Monterey Bay Aquarium Research Institute
7700 Sandholdt Road
Moss Landing, CA 95039
(831) 775-1700 www.mbari.org

Title Variable Bouyancy Wiring Fab, LRAUV Int Press Vess Wiring, Build5		Document Number 100221161	Rev C
Size C	Date: Tuesday, July 31, 2018	Engineer Mellinger	Sheet 5 of 15
Design File \\ATLAS\PROJECTS\LIBRARY\100221161_LRAUVS_BUILD5\DESIGN\DRAWINGS\EE_DRAWINGS\LRAUV_WIRING\SYSTEM_WIRING\100221161_LRAUV_BUILD5_SYSTEM_WIRING\DRAWINGSET_3.DWG			
Schematic Name LRAUVSBuildInternalWiring		Page Name 05 Variable Bouyancy Wiring Fab	Layout File <Layout File>

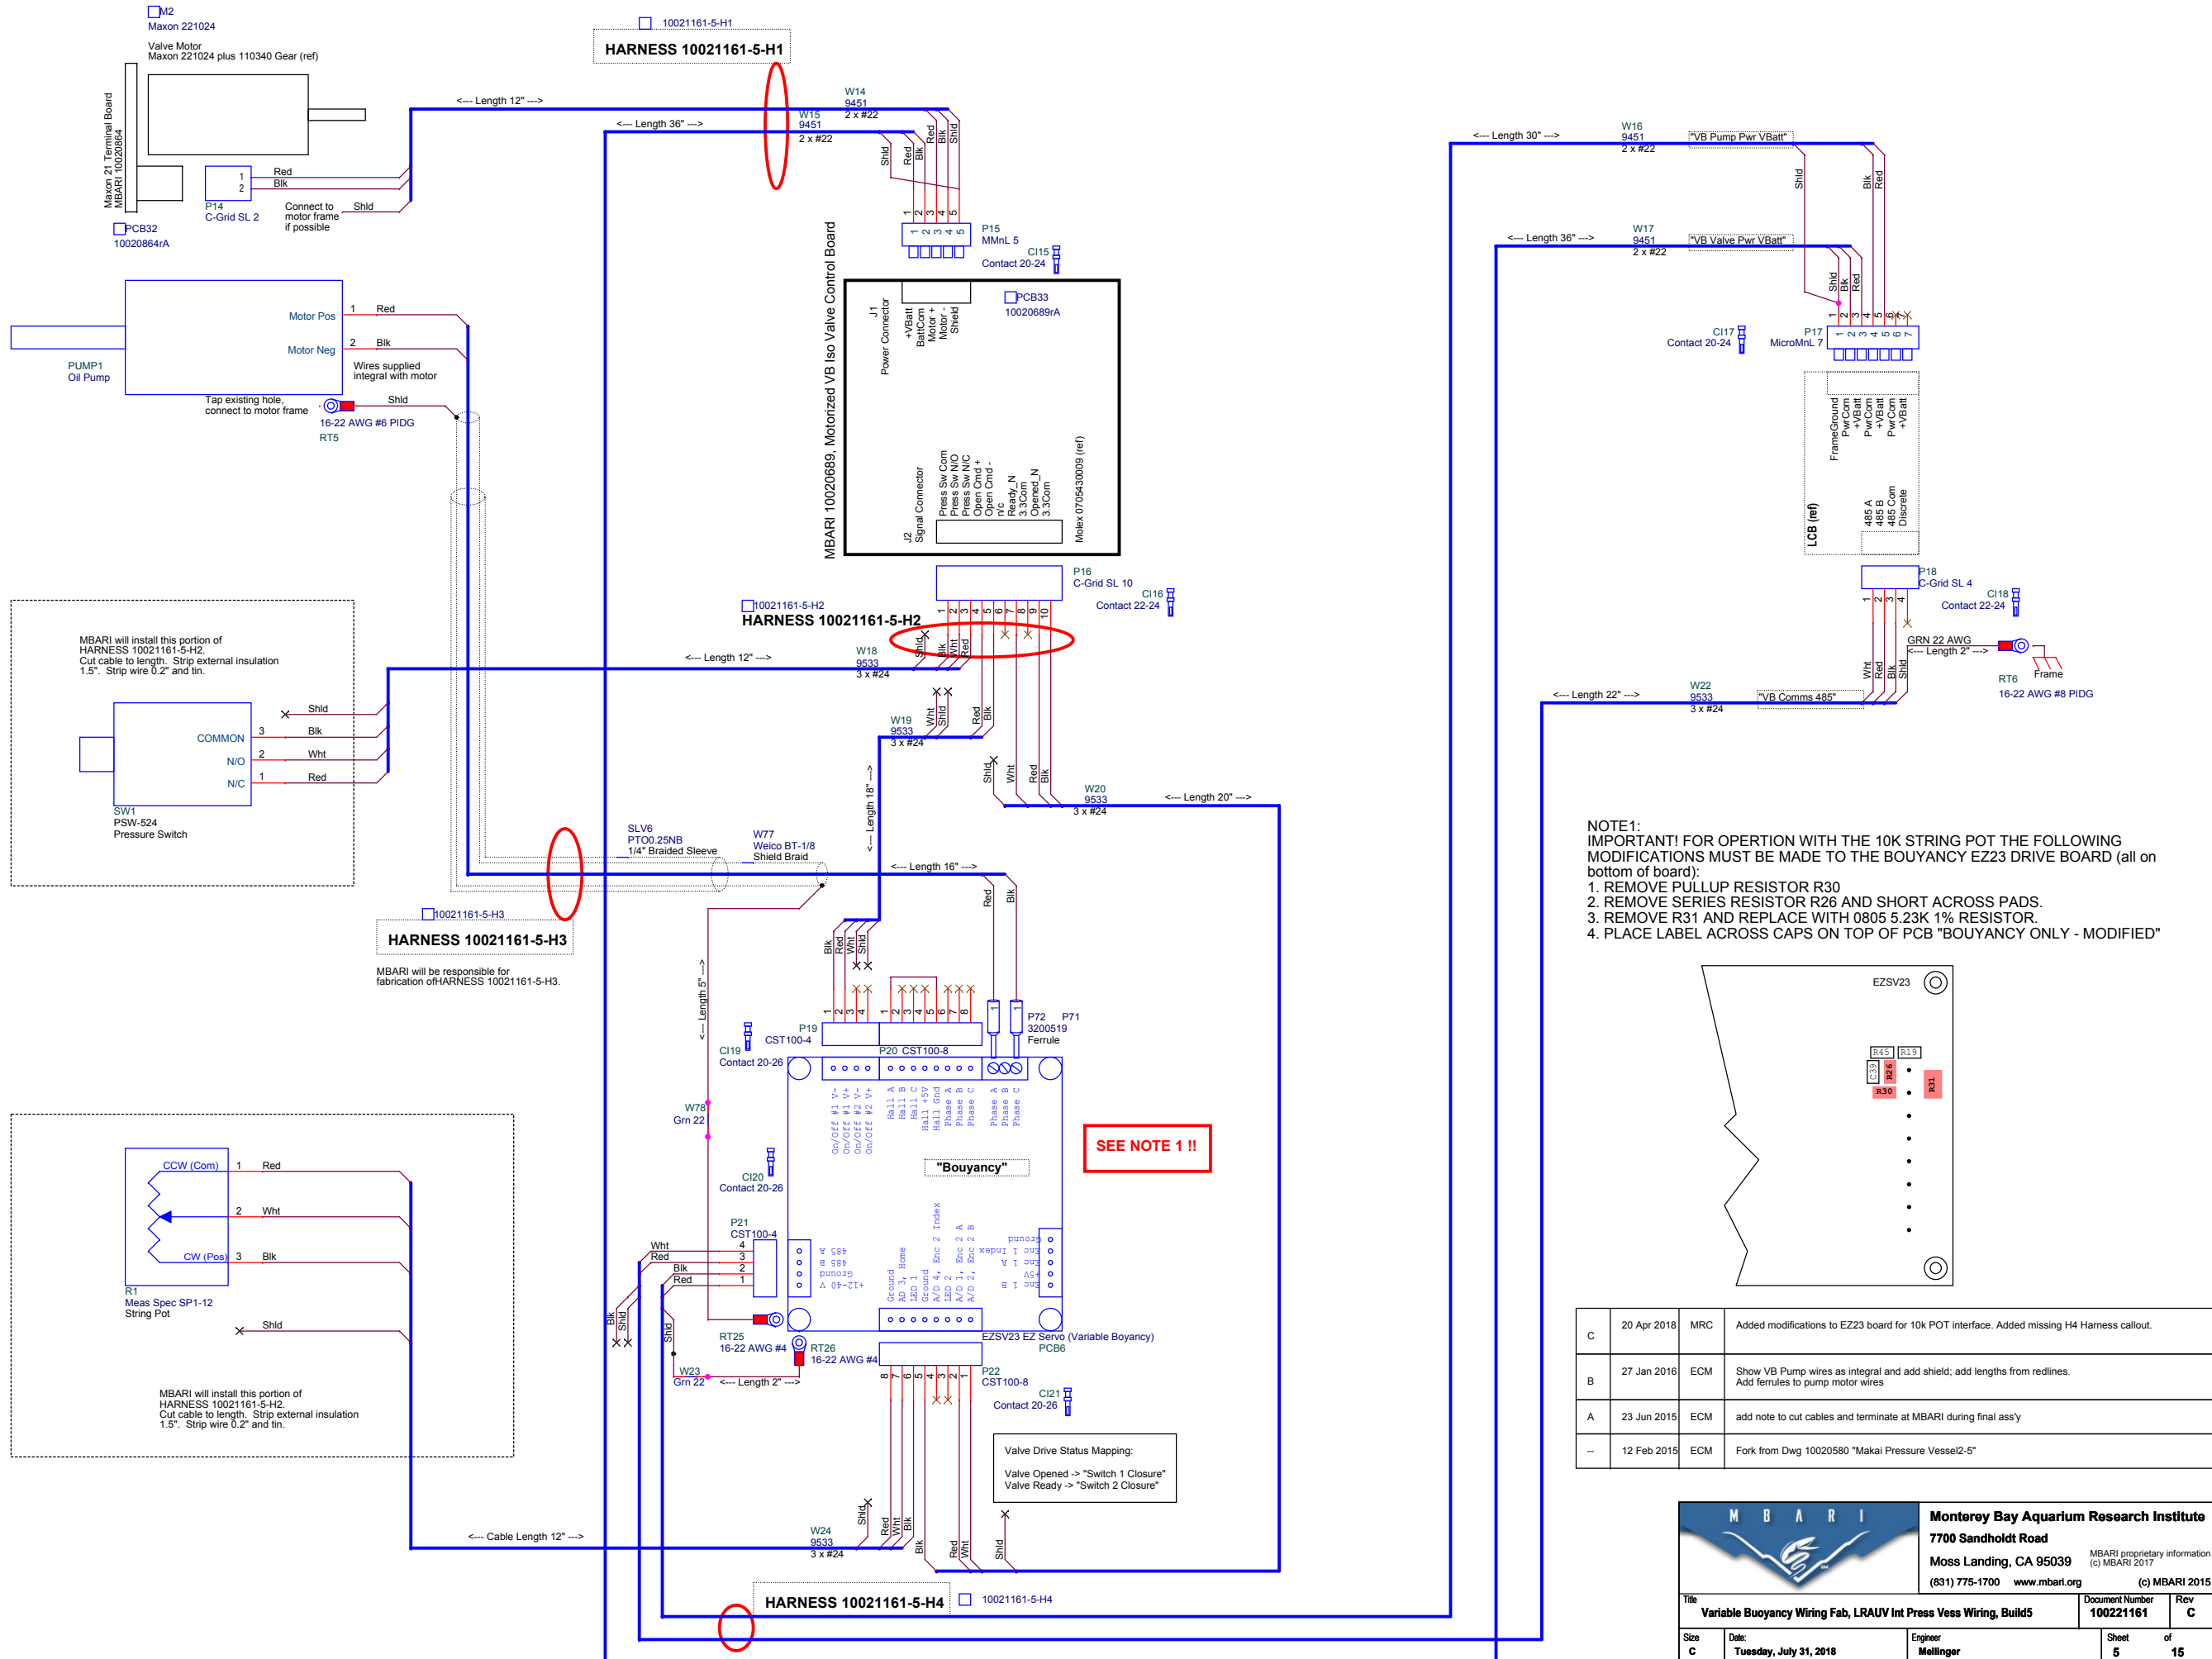
NOTE1:
IMPORTANT! FOR OPERATION WITH THE 10K STRING POT THE FOLLOWING MODIFICATIONS MUST BE MADE TO THE BOUANCY EZ23 DRIVE BOARD (all on bottom of board):
1. REMOVE PULLUP RESISTOR R30
2. REMOVE SERIES RESISTOR R26 AND SHORT ACROSS PADS.
3. REMOVE R31 AND REPLACE WITH 0805 5.23K 1% RESISTOR.
4. PLACE LABEL ACROSS CAPS ON TOP OF PCB "BOUANCY ONLY - MODIFIED"

C	20 Apr 2018	MRC	Added modifications to EZ23 board for 10k POT interface. Added missing H4 Harness callout.
B	27 Jan 2016	ECM	Show VB Pump wires as integral and add shield; add lengths from redlines. Add ferrules to pump motor wires
A	23 Jun 2015	ECM	add note to cut cables and terminate at MBARI during final ass'y
-	12 Feb 2015	ECM	Fork from Dwg 10020580 "Makai Pressure Vessel2-5"
